Access Compliance Report

Public Rights-of-Way

Intersection ID: 14212	Main Street: HAWKINS_ST	Cross Street: W_TREMONT_AV	Location: NW
ADA ID: B66F6E9114CD	Ramp Type: PerpDiag	Initial Pass/Fail: Fail	Overall Compliance: No
Severity Score: 12.5			
Codes/Mitigation Info/Possible Solution		Field Measurements/Component Compliance

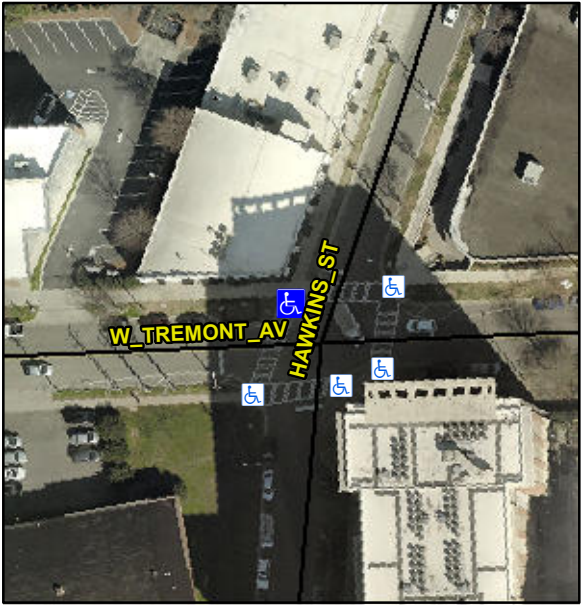
Possible Solutions:						
	Remove & Replace Curb Ramp With Two New Directional Ramps or Equivalent.						
	Surveyor Notes:						
	N/A						
	PROW/ADA:						
	Not Found, R304.5.3						
				Compliance	Description	Data	Compliance
				Description	Data		Description
				Data			Data
		N/A	Ramp Length (in)	91.0	Yes	Ramp Slope (%)	5.6
		Yes	Ramp Width (in)	179.0	No	Ramp XSlope (%)	5.5
		N/A	Flare Type LT	N/A	N/A	Flare Type RT	N/A
		N/A	Flare Slope LT (%)	N/A	N/A	Flare Slope RT (%)	N/A
		N/A	Flare Traversable LT?	N/A	N/A	Flare Traversable RT?	N/A
		N/A	Landing Length (in)	N/A	N/A	DWS Provided?	N/A
		N/A	Landing Width (in)	N/A	N/A	DWS Contrast?	N/A
		N/A	Landing Slope (%)	N/A	N/A	DWS Length (in)	N/A
		N/A	Landing X Slope (%)	N/A	N/A	DWS Full Width?	N/A
		N/A	Landing Curb? (Y/N)	N/A	N/A	DWS Offset (in)	N/A
		N/A	Shared Landing?	N/A			
		N/A	Gutter Ponding?	N/A	N/A	Gutter Slope (%)	N/A
		N/A	Gutter Lip Ht (in)	N/A	N/A	Gutter X Slope (%)	N/A

N/A	Painted X Walk1?	Yes	N/A	Painted X Walk2?	No
			X Walk 1 Direction	To S		X Walk 2 Direction	To E
		N/A	X Walk 1 Width (in)	90.0	N/A	X Walk 2 Width (in)	N/A
			X Walk 1 Slope (%)	4.1		X Walk 2 Slope (%)	5.7
			X Walk 1 X Slope (%)	5.4		X Walk 2 X Slope (%)	1.5
		N/A	Ramp inside XWalk1?	Yes	N/A	Ramp inside XWalk2?	N/A
			Road Slope (%)	5.1	N/A	Clear Space?	N/A
			Road X Slope (%)	5.5	N/A	Clear Space to XWalk (in)	N/A
		N/A	Any Obstructions?	N/A	N/A	Storm Grate/Utility Hazard?	N/A
			Obstruction Type			Storm Grate/Utility Type	
					N/A		N/A
		Yes	Surface Condition? (G/P)	Good			
Total Cost:		\$ 3200.00
